**PROPOSED TEMPORARY PUBLIC VEHICLE PARK (EXCLUDING CONTAINER VEHICLE) FOR A PERIOD OF 3 YEARS AND ASSOCIATED FILLING OF LAND IN "VILLAGE TYPE DEVELOPMENT" ZONE AT LOTS 3669 S.A RP (PART), 3669 S.B RP (PART), 3670 RP (PART), 3671 RP (PART), 3672 RP (PART), 3673 RP (PART) IN D.D.104, NAM SANG WAI, YUEN LONG, NEW TERRITORIES**

**Town Planning Application No. A/YL-NSW/353 - Submission of Further Information (1)**

**PROPOSED TEMPORARY PUBLIC VEHICLE PARK (EXCLUDING CONTAINER VEHICLE) FOR A PERIOD OF 3 YEARS AND ASSOCIATED FILLING OF LAND IN “VILLAGE TYPE DEVELOPMENT” ZONE AT LOTS 3669 S.A RP (PART), 3669 S.B RP (PART), 3670 RP (PART), 3671 RP (PART), 3672 RP (PART), 3673 RP (PART) IN D.D.104, NAM SANG WAI, YUEN LONG, NEW TERRITORIES**  
**(Planning Application No. A/YL-NSW/353)**  
**Response-to-Comment Table**

Figure 6

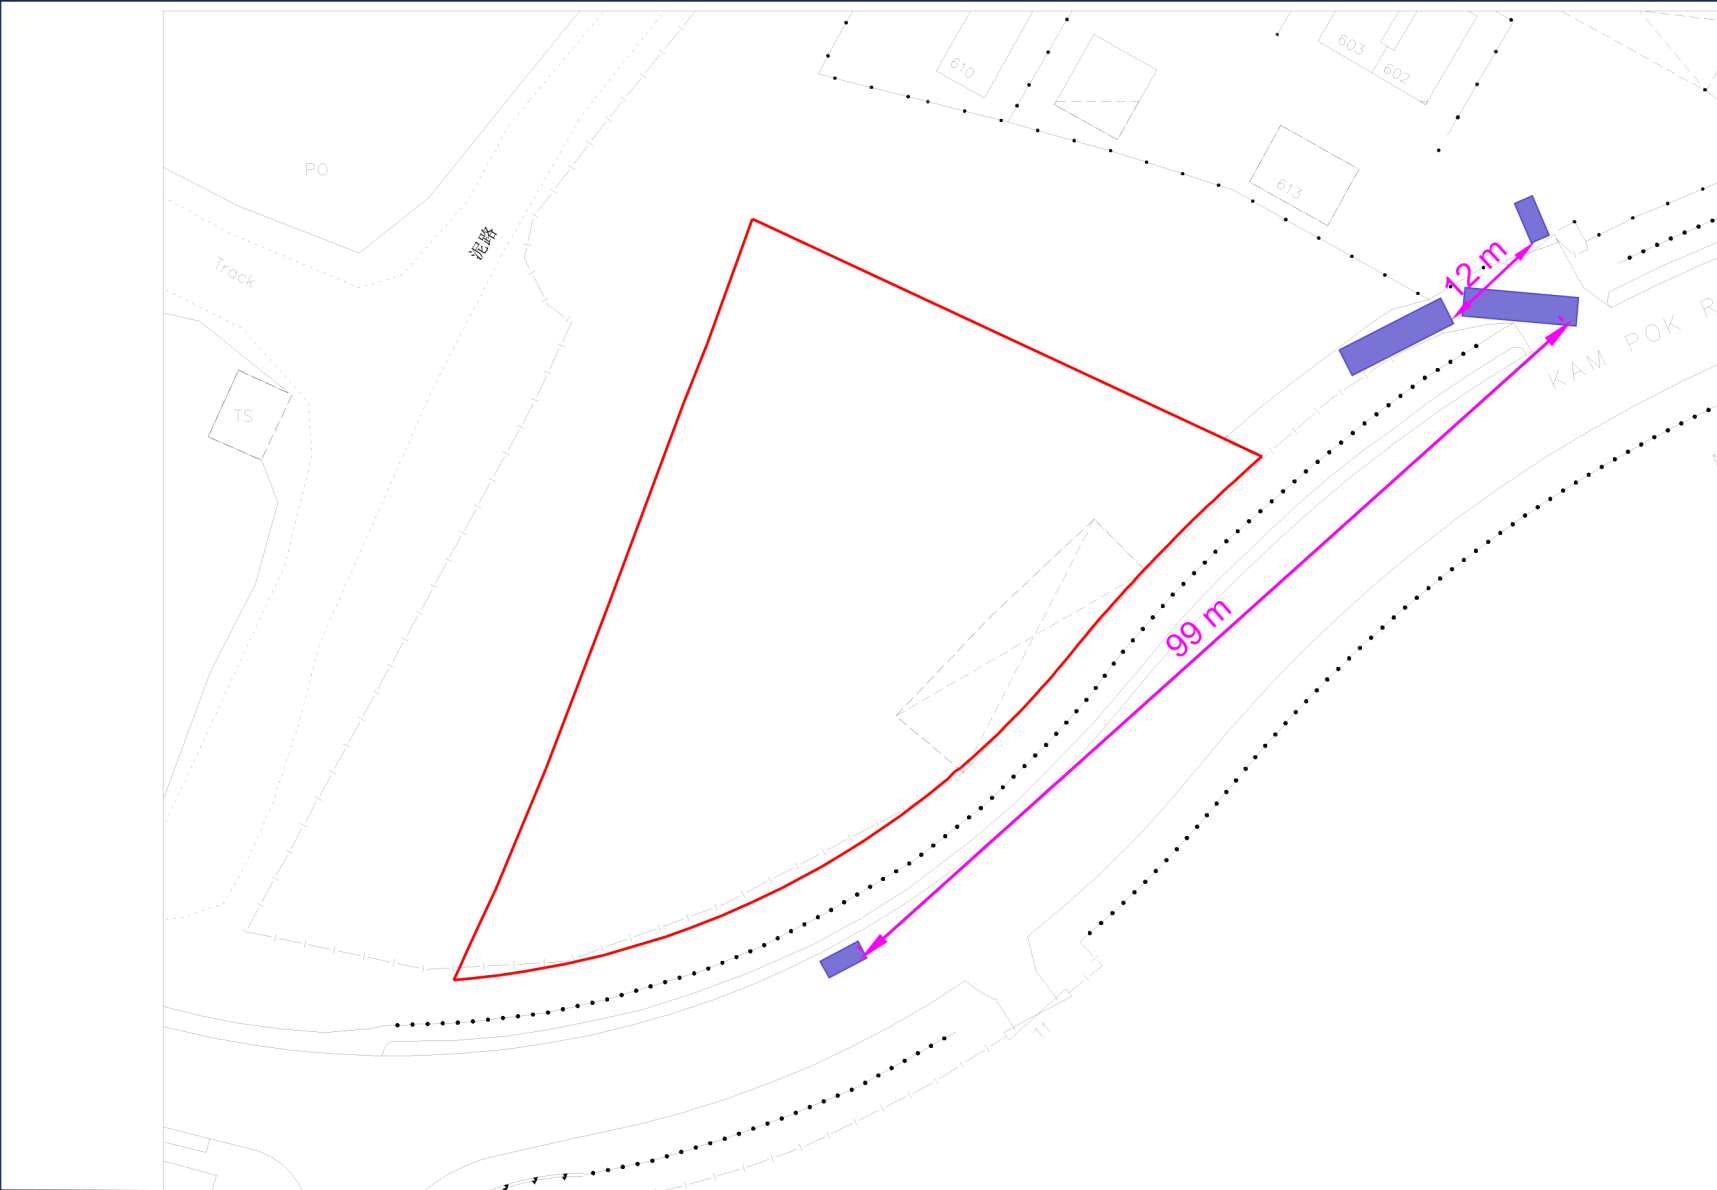
2. Please demonstrate the smooth manoeuvring of vehicles to/from Kam Pok Road East, along the local access to the subject site by providing swept path analysis;	The swept path analysis for vehicles to/from Kam Pok Road East is attached in <b>Figure 6</b> . Smooth manoeuvring of vehicles is ensured to be achieved.

4. Please advise the maximum size of coach that is allowed to park in the subject site. Please adopt the largest size of vehicle that would enter the site in the swept path analysis;	The maximum size of coach will be 12m (L) x 2.5m (W). Please see the swept path analysis in <b>Figure 6</b> .
